## **Board of Adjustment Meeting**

**AMENDED STAFF REPORT TO THE  
NORMANDY PARK BOARD OF ADJUSTMENT**

CASE #: V07-01

**Re: Response to Geotechnical Review of Documents  
Coluccio Property – Proposed Retaining Wall  
19417 Edgecliff Drive SW  
Normandy Park, Washington**

## 9' Soldier Pile @ 6' OC w/ Deadman

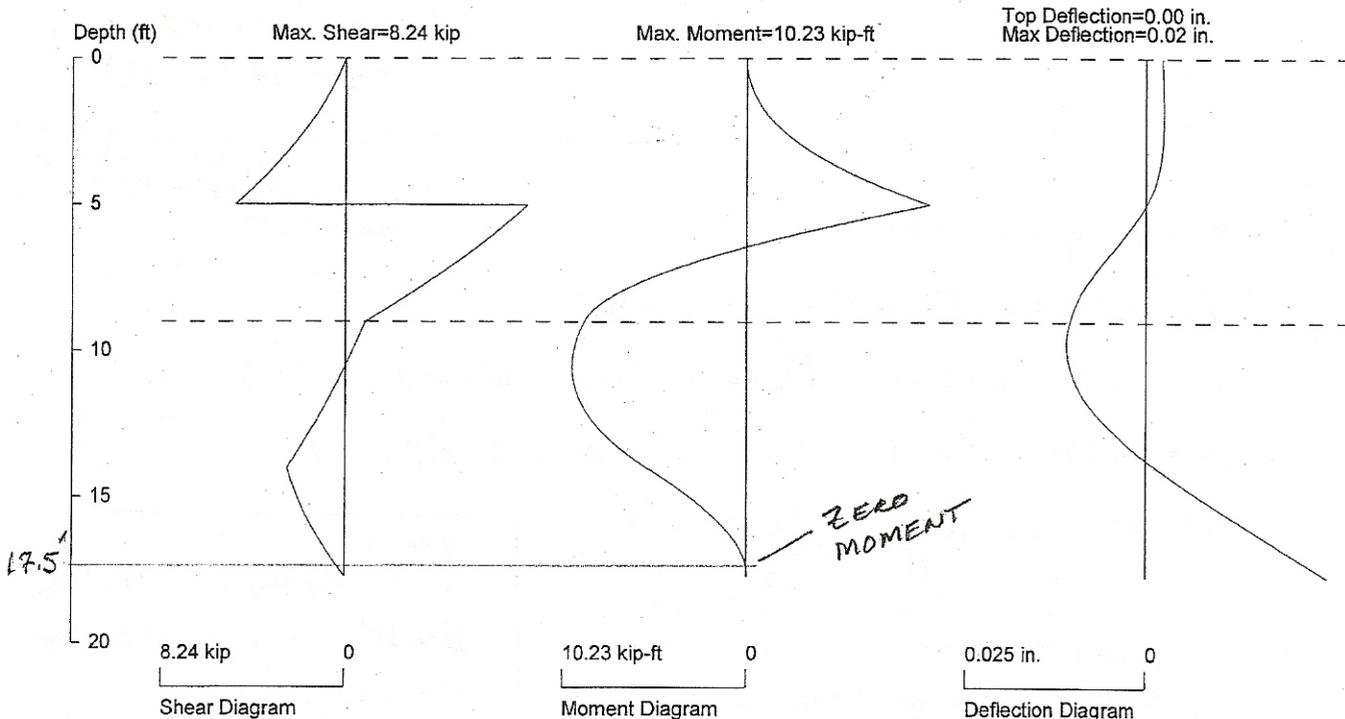
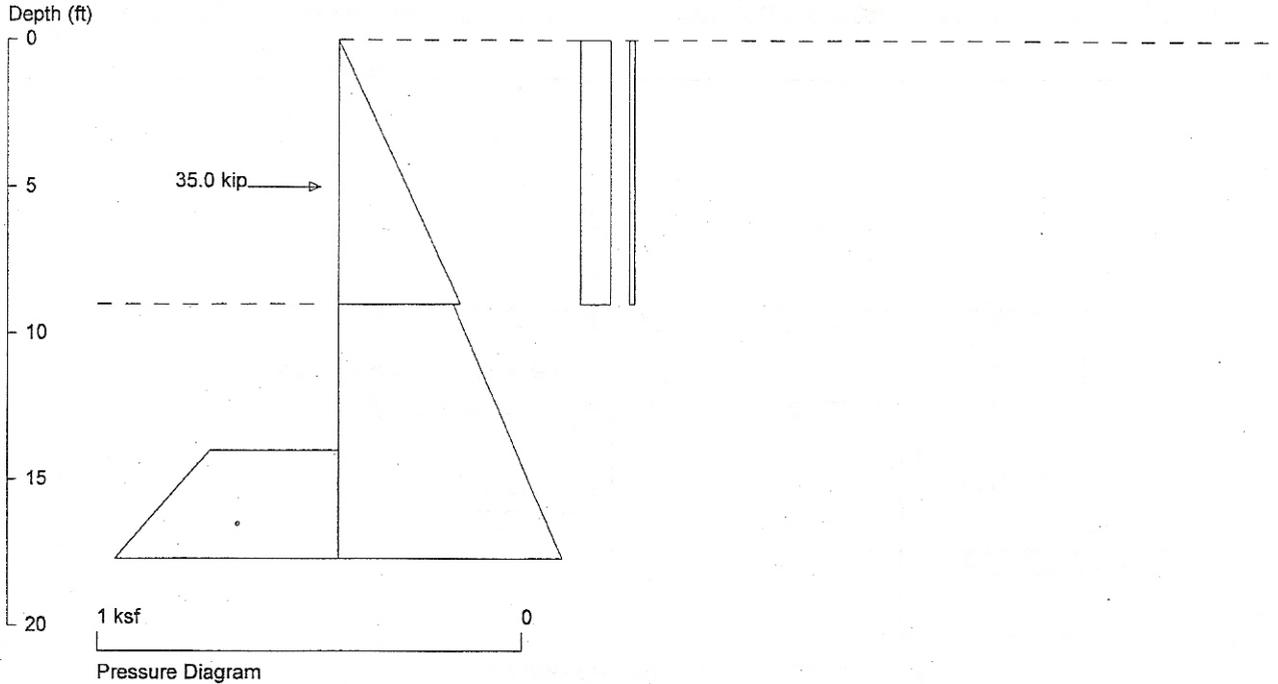
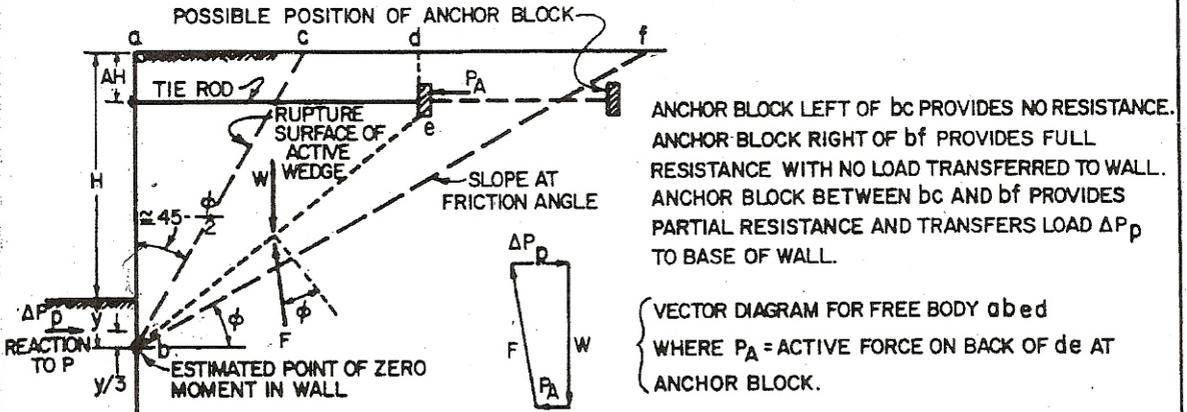
- 3) HWA state that the top of the new soldier pile wall will be tied back with permanent anchors to the new basement wall. The design for such a configuration needs to consider the overlapping active soil zone from the soldier pile wall and the passive resistance zone from the basement wall. Has the geometric relationship between these two zones been assessed? This is particularly important where the basement wall and soldier pile wall are in close proximity to each other in the northwest corner of the house/wall.

Response: The geometric relationship was assessed for the worst-case conditions described where the new soldier pile wall is approximately 18 feet from the basement wall. Based on the shoring program output, the minimum tie rod length is 14.9 feet,

indicating the spacing is adequate. We have subsequently done a check using the method described in NAVFAC DM7.2, indicating a passive capacity of 80k for these conditions (see attachment). This compares to an anchor load of 35k. Conservative assumptions were used in the analysis, including assuming that only a small area of the foundation wall acts as an anchor and ignoring the weight of the foundation.

Figure 10 - Coluccio Residence Stability Evaluation  
Post Development Condition - Static Case  
Sliding Block Failure Mode - Elevated GW

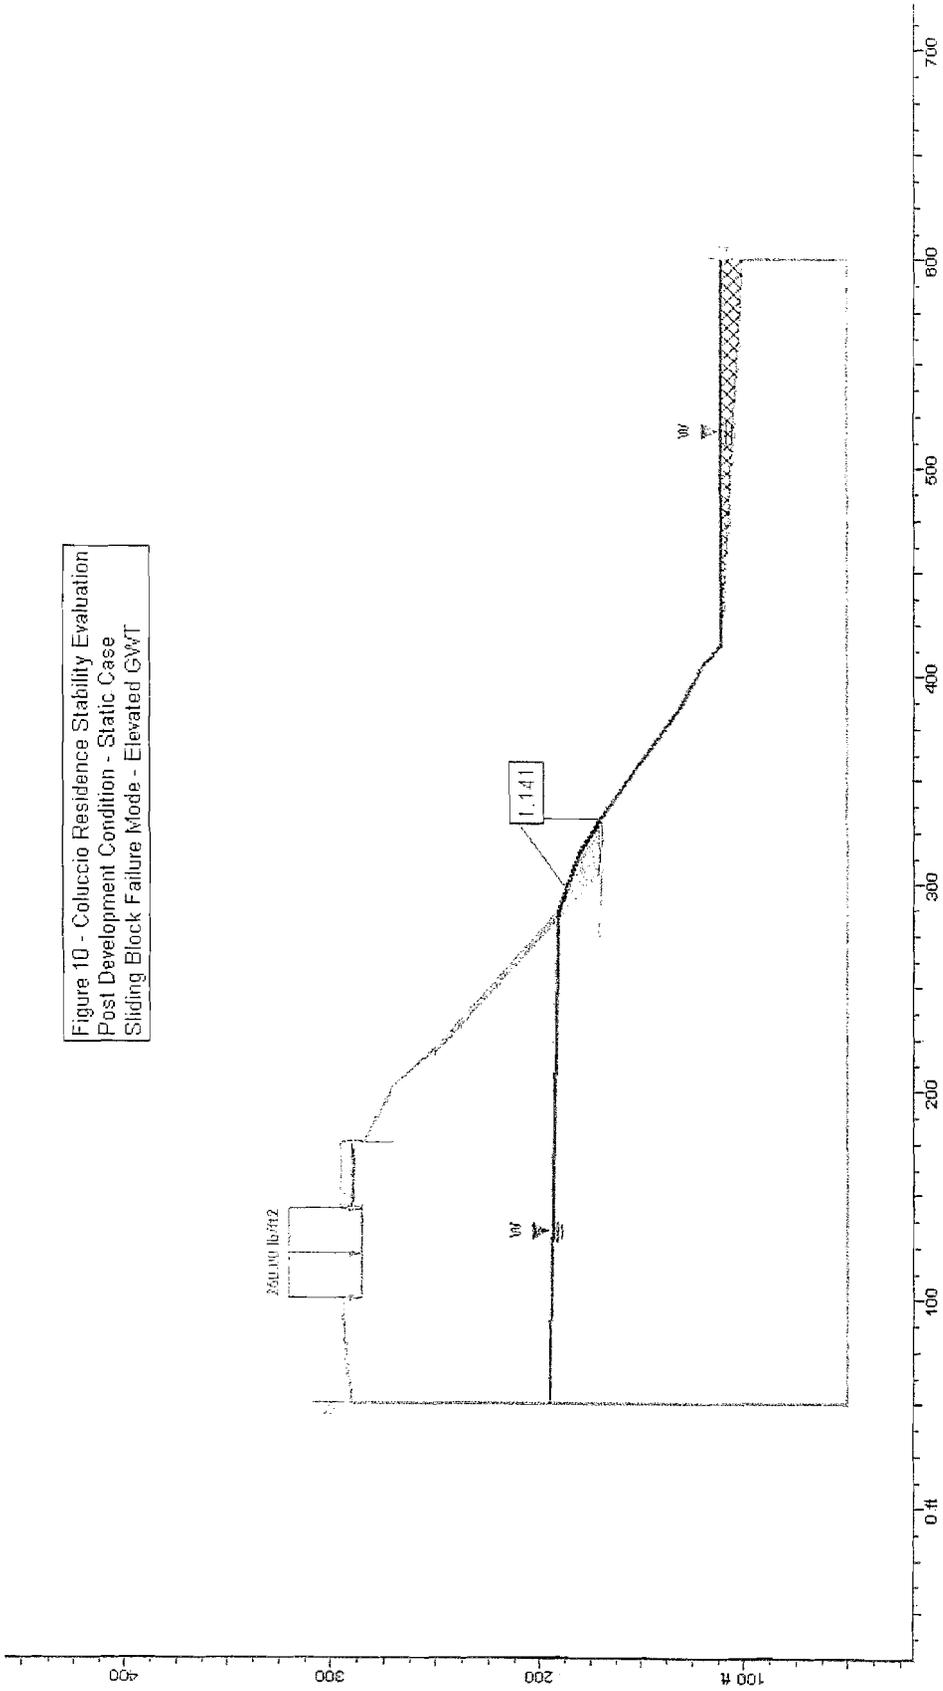
In Item 5), AMEC make reference to the "1997 Woodway Slide" as an example of a large scale failure that they contend occurred "...in similar soil conditions in recent years, apparently due to high groundwater pressures and "blow-out" or extensive seepage and internal soil erosion." AMEC continued on to "...recommend that HWA discuss failure conditions relative to this failure mode, including observed groundwater, calculated factor of safety, and consequences of failure on the planned residence and new retaining wall."

In response to AMEC's comment, we note that whereas the site stratigraphic conditions are somewhat similar to those of the Woodway Slide site, we contend that there are sufficient differences that distinguish these sites and contribute to more favorable conditions at the subject site. Firstly, the subject site appears to be underlain by a thicker surficial deposit of glacial till, interpreted by RH2 Engineering, Inc. (RH2) to be of the order of 50 feet thick; based, presumably, on the observations in the Civiltech Engineering (Civiltech) boring B-1-05 and their slope reconnaissance. The Civiltech boring was advanced on the site to a depth of 51.5 feet. According to RH2, the base of the glacial till and contact with advance outwash exists at about elevation 150 feet. The base of the advance outwash is indicated by RH2 to be about 80 feet deeper, or about elevation 70 feet, at which level a Lawton Clay unit was observed and apparently extends to and below the toe of the slope at about elevation 10 feet.

Our second point is that we based our slope stability modeling on ground water observations and hydrogeological reports for the area that indicate an upper ground water table near the base of the advance outwash. Employing this information, we ascertained that the piezometric surface is likely to be close to that shown in our stability analyses, included as Figures 1 through 9, with our report on the site dated February 2, 2006. Existing site conditions and observations do not support a water table much higher than we have employed for our analyses. Notwithstanding, we have analytically examined the potential influence of a rapidly increasing piezometric level within the advance outwash unit, as depicted in Figure 10, attached herewith and intended to supplement the figures in our earlier report. We have assumed that the accumulation of colluvium near the base of the advance outwash, at about mid-slope level, could conceivably act as a short-term dam to allow the ground water level to rise to the top of the colluvial accumulation. Our analysis of this condition shows that the most critical failure mechanism, based on a sliding block failure mode, is limited to the colluvial wedge itself. Even then, the factor of safety (FS=1.14) for this condition is greater than one. If a failure were to occur by way of a blow-out of built-up piezometric pressure, we would anticipate that it would be confined to the lowermost section of the advanced outwash unit, which might induce progressive failure back up the slope, but we believe that such regressive failure would be shallow in nature and not progress below the base of the piles supporting the wall.
